**DCE MEMORANDUM NO. 09-18**

**SUBJECT: PAVEMENT MARKING MATERIAL CERTIFICATION**

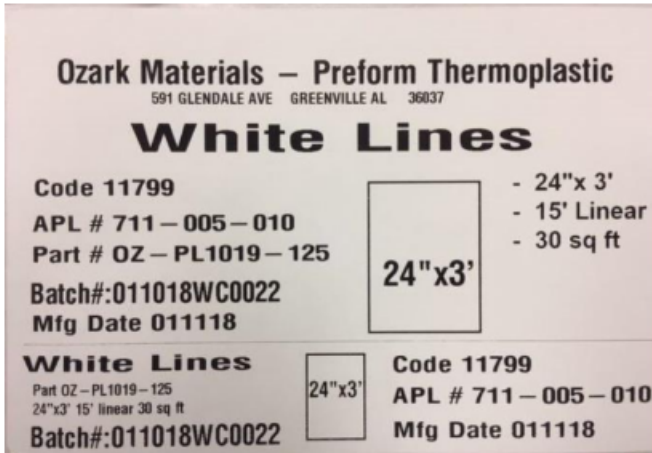
**Specification 971-1.1 Packaging and Labeling** requires the name and address of the manufacturer be shown on the label. The label must also show the color, date of manufacturer, lot number and APL number. An example of this requirement is shown below for reference.

The Department will now allow 701, 709, and 711 materials with labels as shown above to be provided for pavement marking materials that meet the requirements of 971-1.1 without providing material certifications. This material acceptance memorandum does **NOT** apply to Specification 710 Painted Pavement Markings as it will still require material certifications.
